# **RANCHO SANTIAGO COMMUNITY COLLEGE DISTRICT**

## **ADDENDUM NO. 02**

Bid #1434  
at  
CAMPUS ENTRANCE IMPROVEMENT – PHASE 1 PROJECT

Project ID #3739, DSA #04-121029

**SHEET NUMBER:** CD-1.3

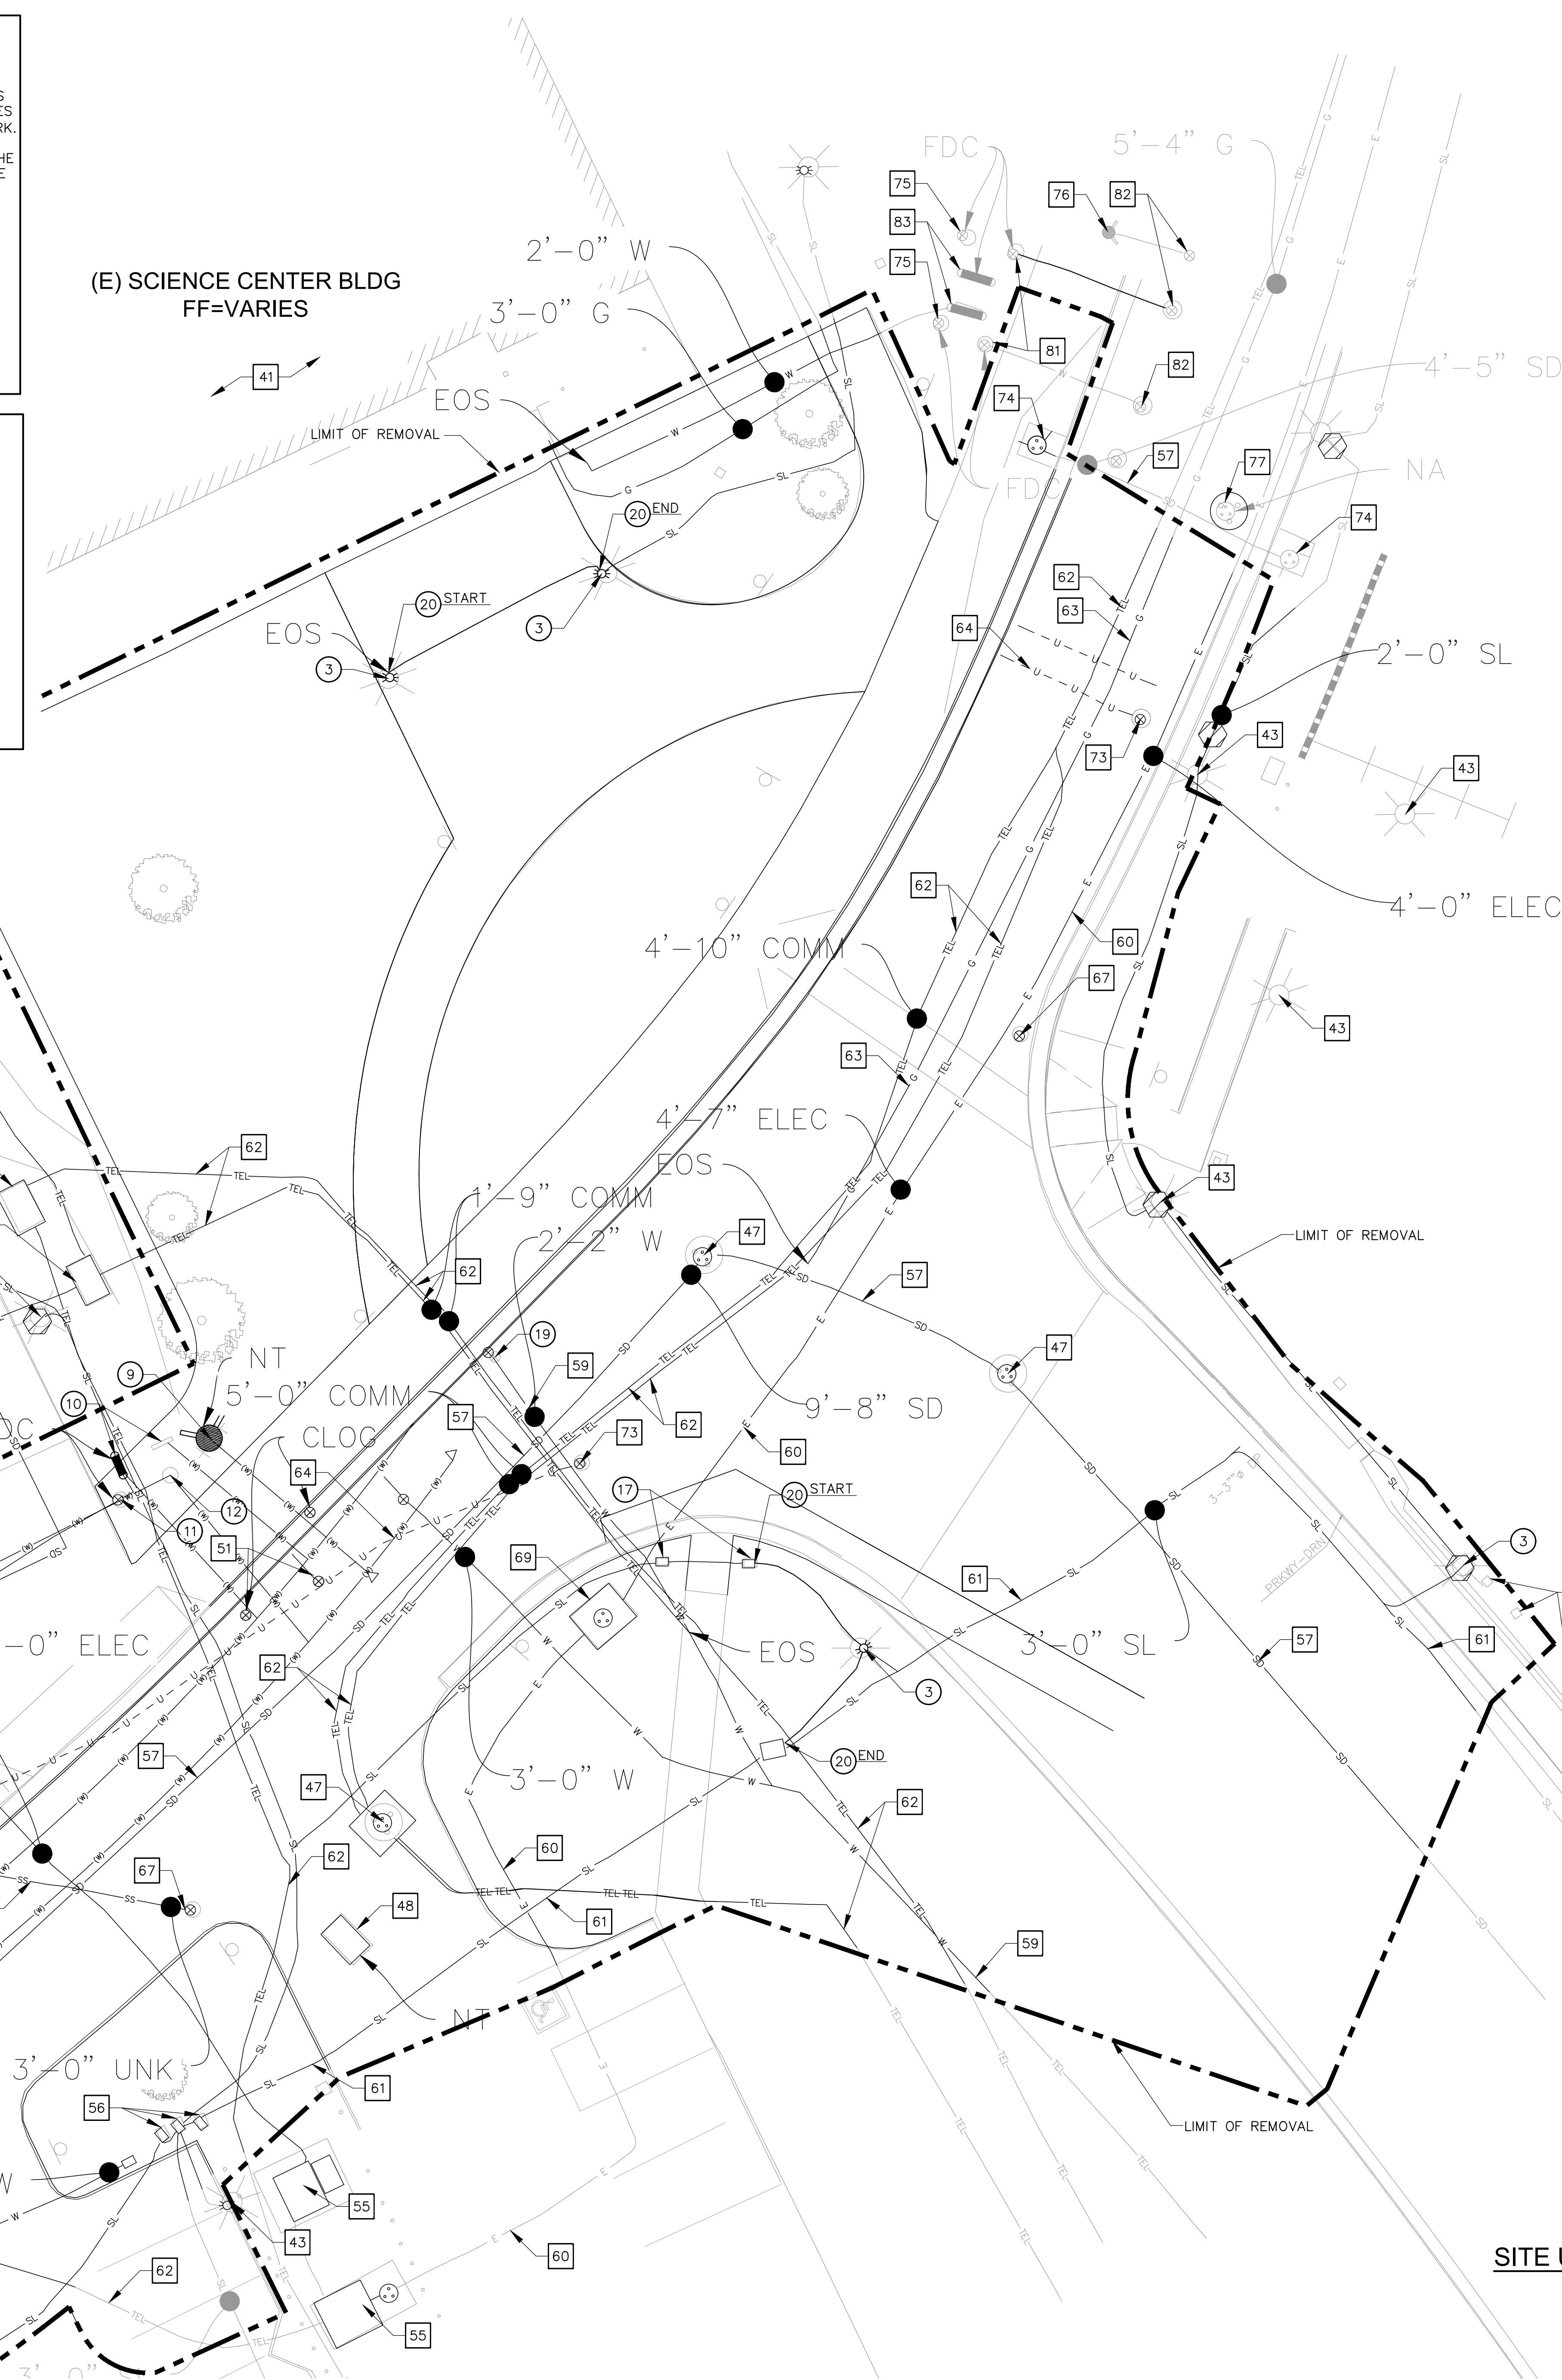
Provide a brief description of construction scope for this post-approval document (attach additional sheets if needed): <u>Updated sheets CD-1.3, C-4.1 &amp; C-5.2 to remove an existing gate valve by adding a note and detail. Revised note on Landscape detail G/L-4.01 to use PVC SCH.40 and detail H to use SCH.80 nipple MIPT and slip match valve size. Added note on sheet L-501 to add root barrier at trees within 8-ft. of hardscape. Added note #4 on 6/L-6.01 to add 4-inch mulch layer. Updated the electrical sheets to add a note and detail to add addition security cameras.</u>			
List of DSA-approved drawings affected by this post-approval document: <u>Civil sheet(s): CD-1.3, C-4.1, C-5.2, Landscape sheets: L-4.01, L-5.01, L-6.01 and Electrical Sheet(s): E-103 and E-501</u>

- REMOVE AND RELOCATE EXISTING ELECTRICAL PULLBOX PER ELECTRICAL DRAWINGS.
- REMOVE EXISTING WATER VALVE AND PROVIDE NEW BRASS PIPE CONNECTION PER DETAIL 3 ON SHEET C-5.3.

**DATE ISSUED:** 2018-11-19  
**PROJECT NO:** 2018-40167  
**DSA APPLICATION NO:** 04-121029  
**SCALE:** As indicated  
**SHEET NUMBER:** C-5.3  
**SHEET TITLE:**

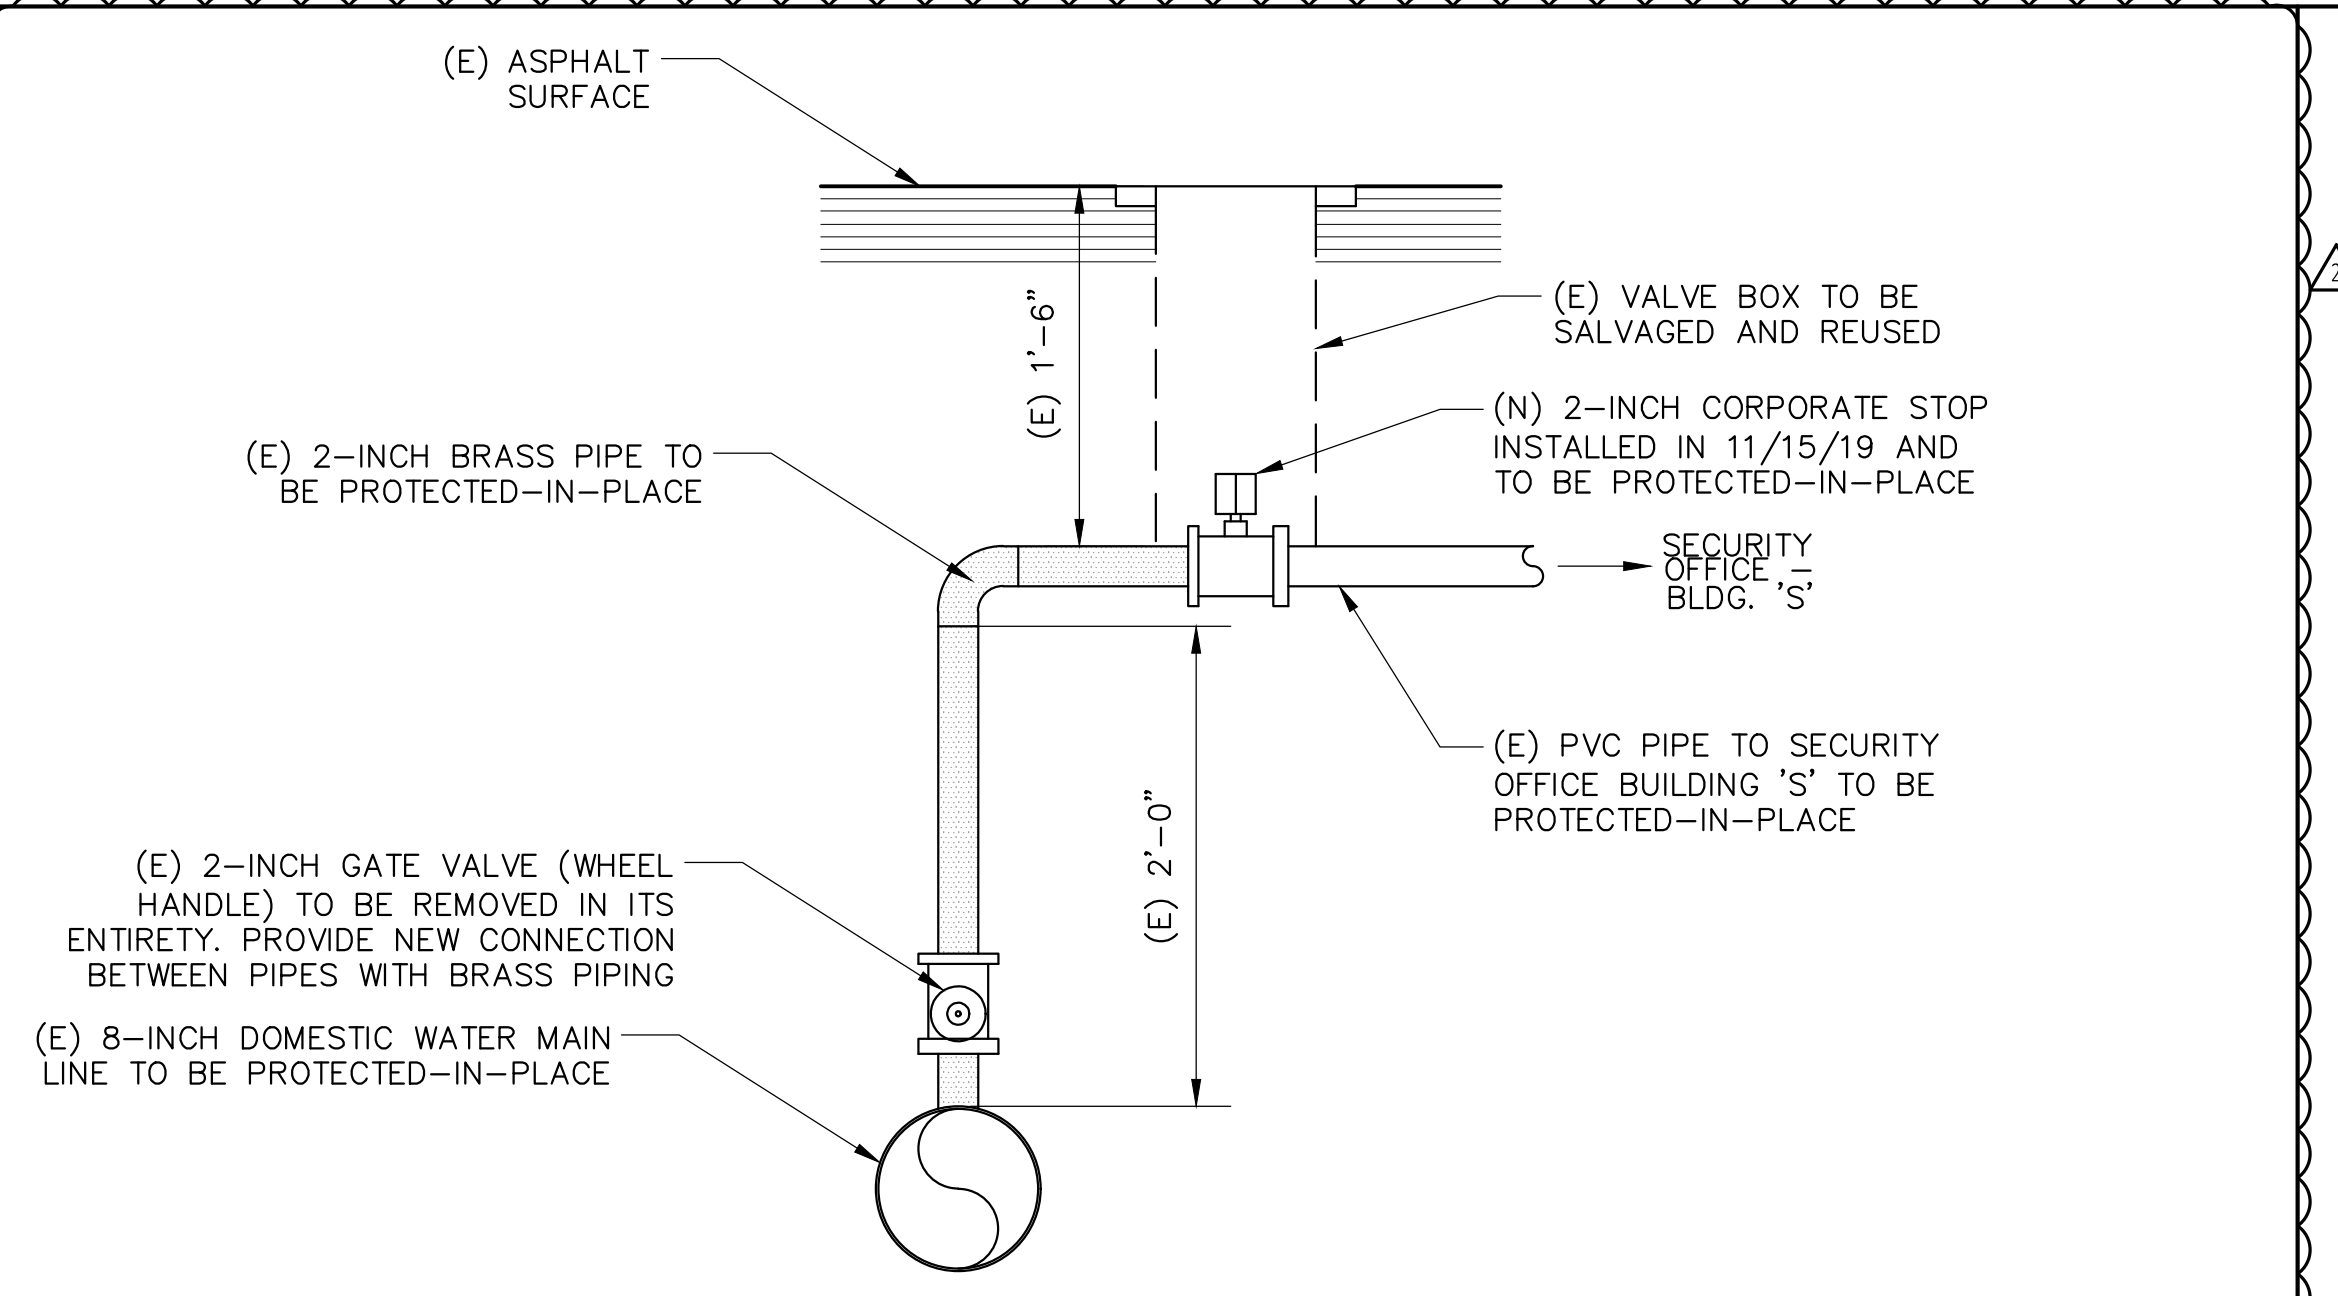
**NOTE:**  
1. PRIOR TO COMMENCING WORK, CONTRACTOR TO COORDINATE WITH DISTRICT PM TO REVIEW REMOVAL OF GATE VALVE AND INSTALLATION OF PIPE TO MAINTAIN WATER CONNECTION.
